mk1 C920 PCBA wiring

New C920 wiring

Recently updated C920 webcam version was released featuring new PCB. These changes introduced two unexpected issues: wiring is different and new PCB has mechanical interference with aluminium rework kit back plate.

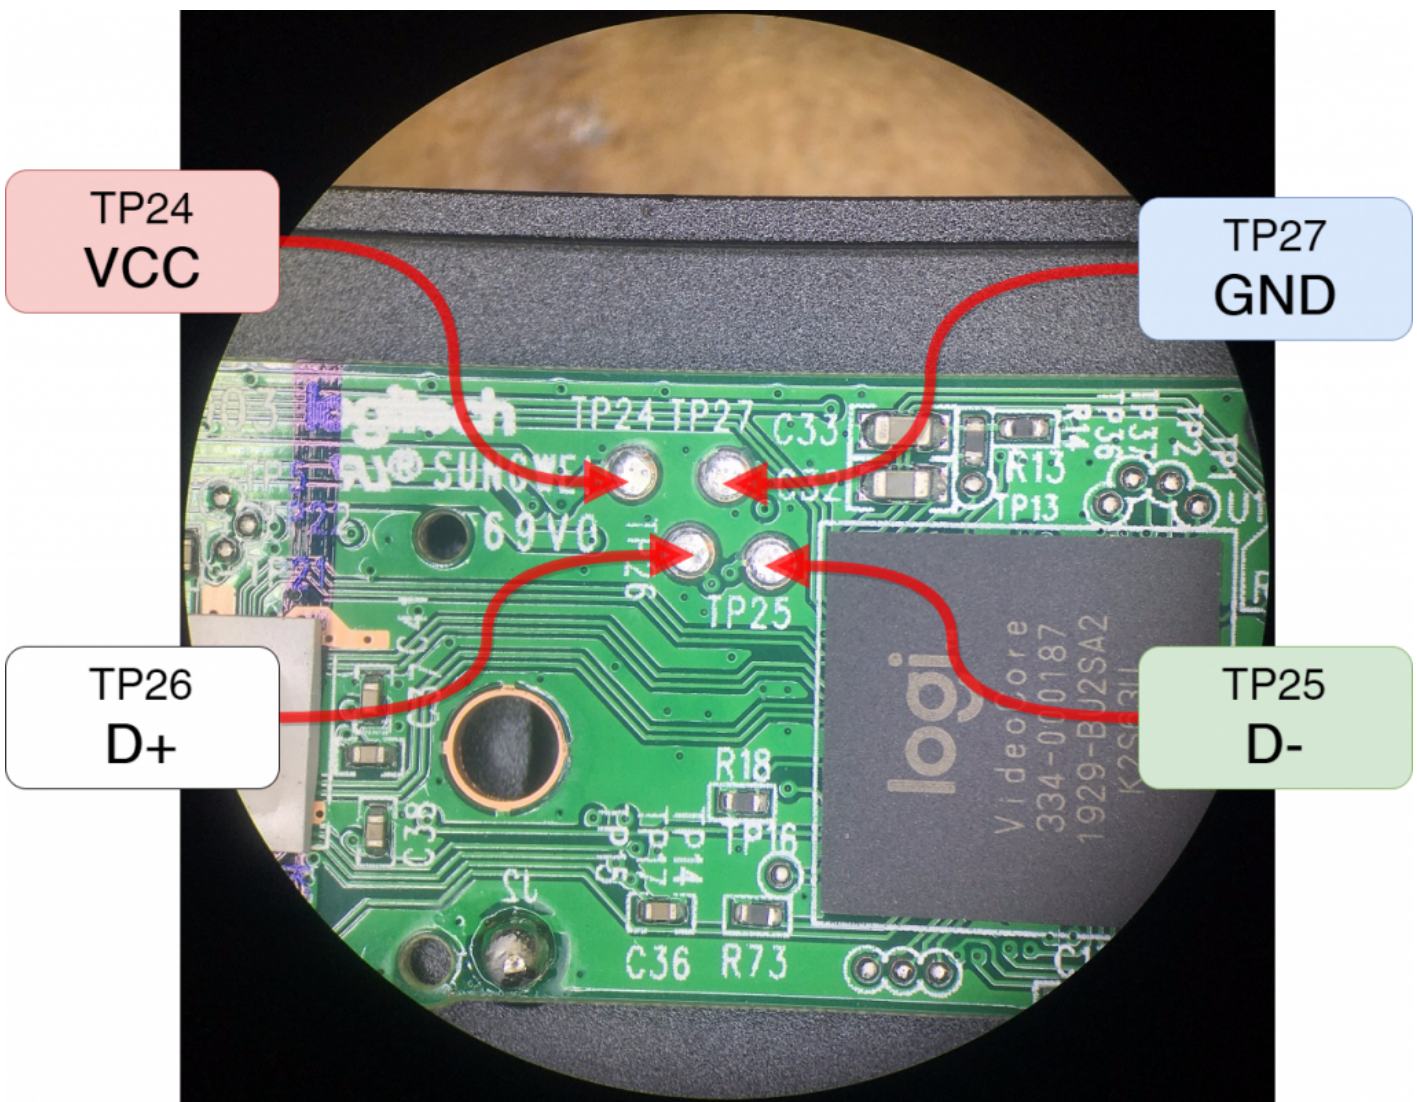
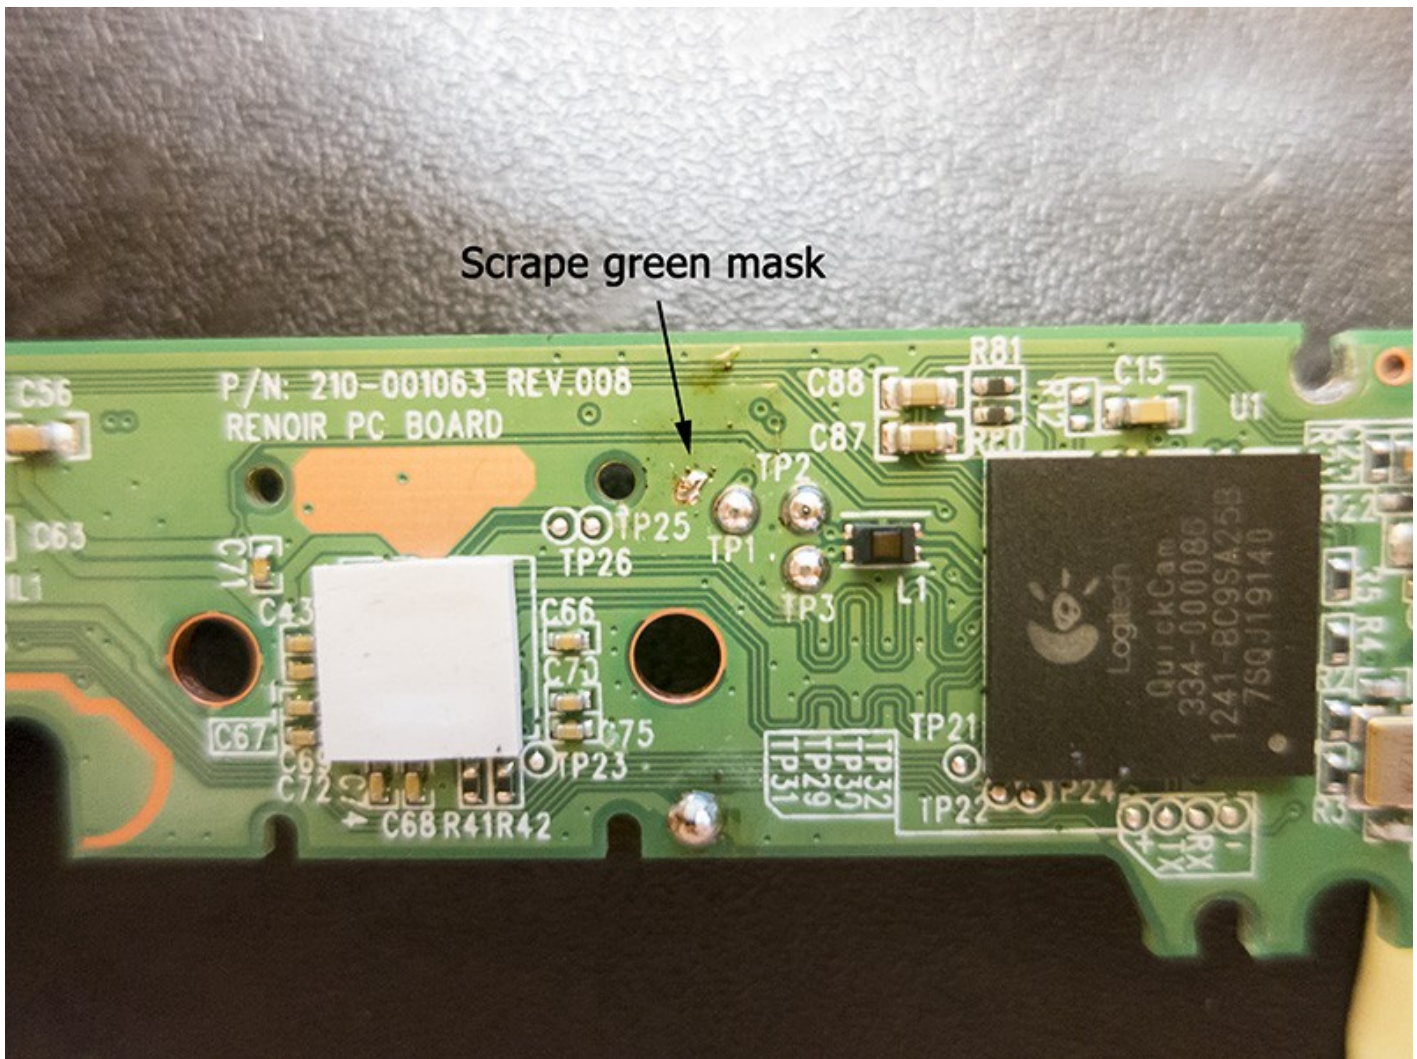
If you rework webcam by yourself, please use pin-out diagram as pictured below to solder wires.

Test point	Signal
TP24	VCC
TP26	USB D+
TP25	USB D-

green soldering mask with scalpel to access GND.
